Agenda Item # 5

SUB-002724-2023 & ZON-UDC-002730-2023

Perch Creek - Dockside Marina Subdivision

- Subdivision approval to create two (2) legal lots of record.
- Rezoning from B-3, Community Business Suburban District to B-3, Community Business Suburban District to remove a previous condition of rezoning approval limiting development of the site to a Planned Unit Development.
 - Any use permitted in the proposed district would be allowed at this location if the zoning is approved. The Planning Commission may consider other zoning districts than the proposed sought by the applicant for this property.

SITE PLAN

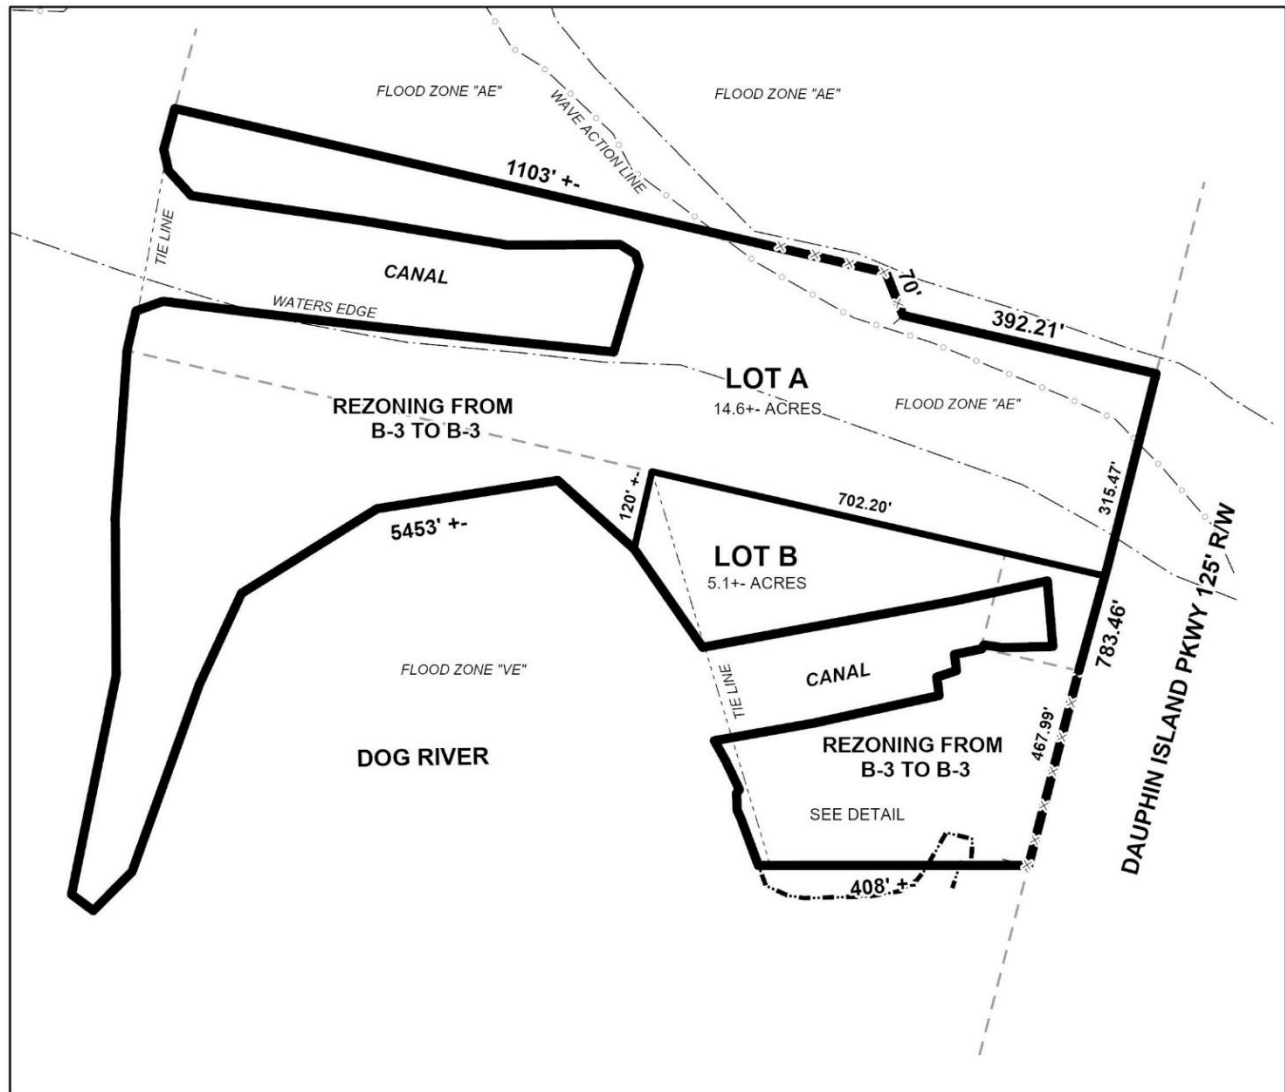
- F. Show and label the MFFE (Minimum Finished Floor Elevation) on each lot that contains an VE, A, AE, or X (shaded) flood zone designation. BFE = 14.

- G. Revise NOTES #16 to read "As shown on the 1984 aerial photo (FLIGHT 27 - #89) LOT A?1? will receive historical credit of existing (1984) impervious area towards stormwater detention requirement per Mobile City Code, Chapter 17, Storm Water Management and Flood Control) as follows: LOT A?1? – 12,000 sf."

The preliminary plat submitted provides the proposed lot size in both square feet and acres, which exceed the minimum lot size for a B-3 Community Business Suburban District and if approved, should be retained on the Final Plat.

The site has frontage along Dauphin Island Parkway, a principal arterial road per the Major Street Plan, which should have a minimum right-of-way width of 100-feet. The preliminary plat depicts an existing compliant right-of-way of 125-feet, making no dedications necessary.

As proposed, the 25-foot minimum front setback is not depicted along the frontage, and should be depicted on the Final Plat, if approved.

1. Retention of the existing right-of-way for Dauphin Island Parkway;
2. Retention of the lot sizes in both square feet and acres, or the furnishing of a table on the Final Plat providing the same information;
3. Revision of the plat to illustrate a 25-foot minimum building setback line along Dauphin Island Parkway;
4. Compliance with all Engineering comments noted in this staff report;
5. Placement of a note on the Final Plat stating all Traffic Engineering comments noted in this staff report;
6. Compliance with all Urban Forestry comments noted in this staff report; and,
7. Compliance with all Fire Department comments noted in this staff report.
